RE: Data Request #2 - Certificate of Public Convenience and Necessity for the Riverside Transmission Reliability Project – Application No. A.15-04-013

REQUEST FOR ADDITIONAL DATA: DATA NEEDS #2 FOR THE RIVERSIDE TRANSMISSION RELIABILITY PROJECT - APPLICATION (A. 15-04-013)

Exhibit A: Underground Transmission Line Route (Map 1)

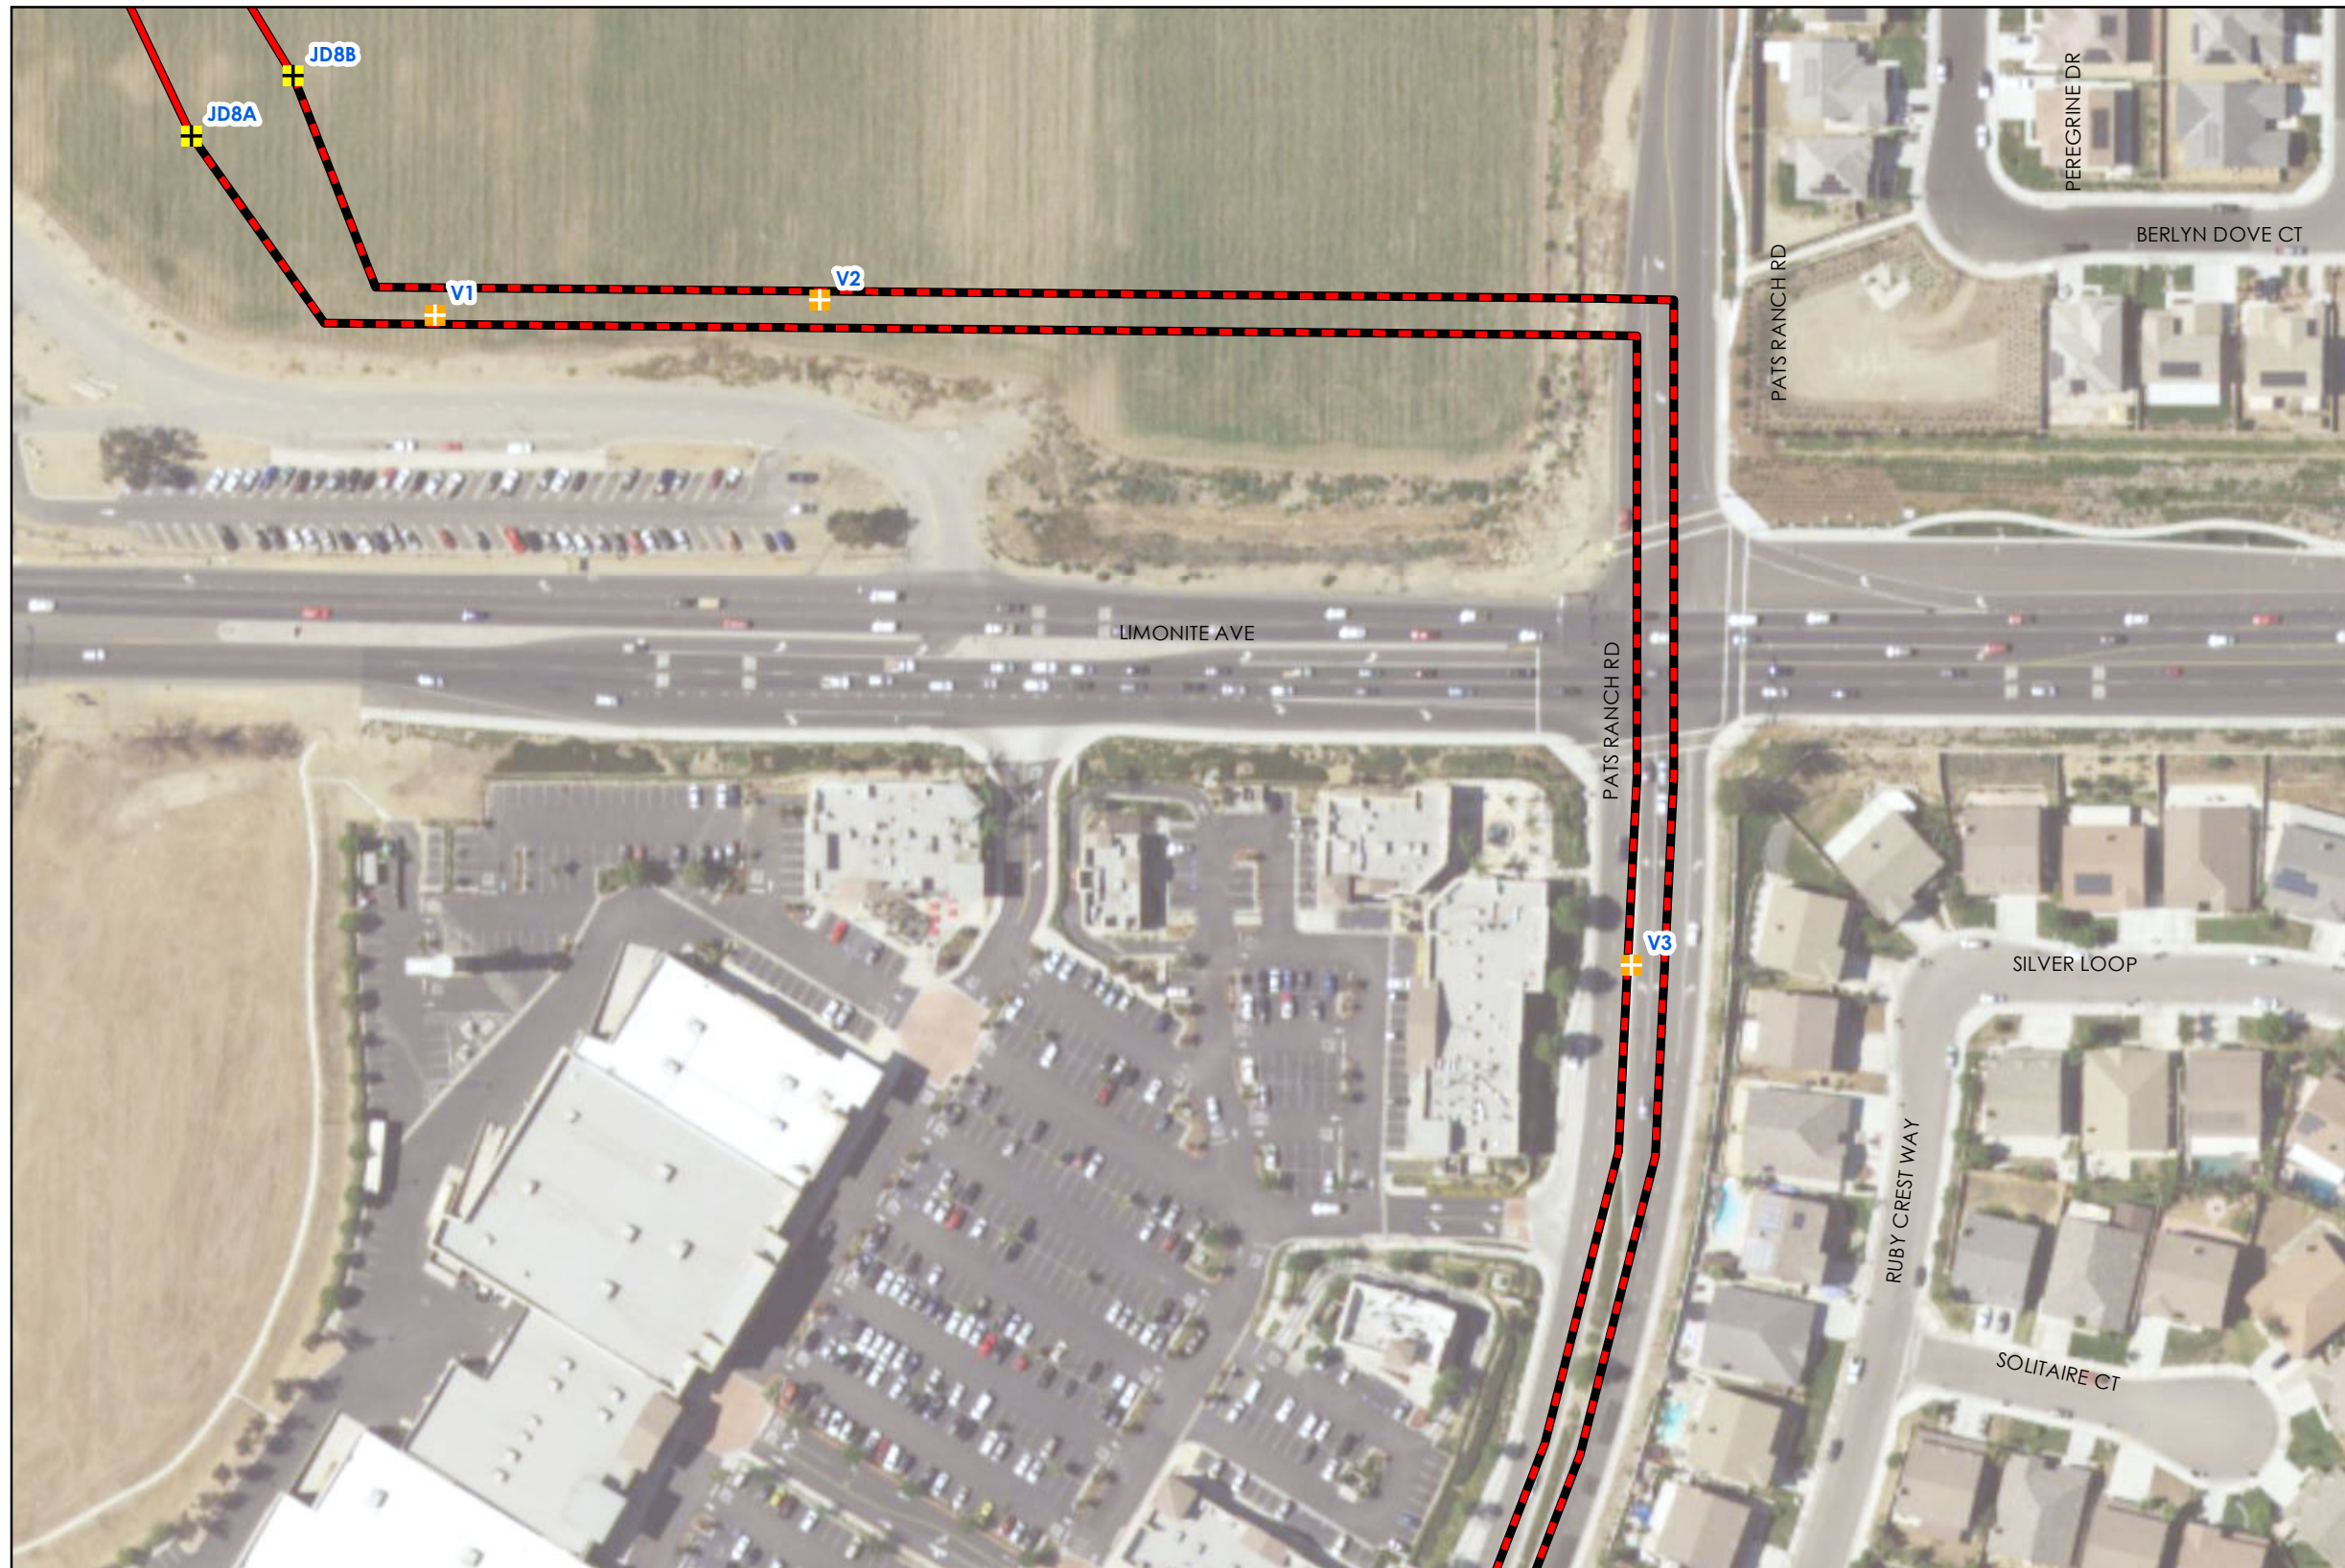
PD-8	<p>Provide information on the anticipated frequency and duration of maintenance activities for the proposed underground alignment.</p> <p>Please specify how often maintenance would be likely to occur (annually, every two years, every three years, etc.) and the length of time needed for maintenance activities. Clarify if underground transmission line maintenance and testing would require traffic lane closures.</p>
PD-9	<p>Verify that the 90-degree-angle bends shown in Exhibit A (attached) on Pats Ranch Road north of Limonite and on 68th Street at the Goose Creek Golf Course are technically feasible in the tight radius shown and with the proposed vault structure locations as presented.</p>

Table 1: SCE Riverside Transmission Reliability Project Application 15-04-013 Data Needs #2	
Number	Data Need
	Provide GIS and PDF maps indicating any further refinements if these bends or vault structure locations do not accurately represent an approximation of the underground alignment.
PD-10	Provide GIS that identifies the required easements and right-of-way for the underground and overhead transmission line alignments, including designation of existing easements and any modifications that are necessary.
PD-11	Provide a description of how underground construction would be sequenced and completed in the Goose Creek Golf Course. Identify locations where existing structures or vegetation would be removed. Please also identify activities and durations of any proposed nighttime construction.
PD-12	Provide a description of riser pole construction. Identify if helicopters or cranes would be used to place the poles.
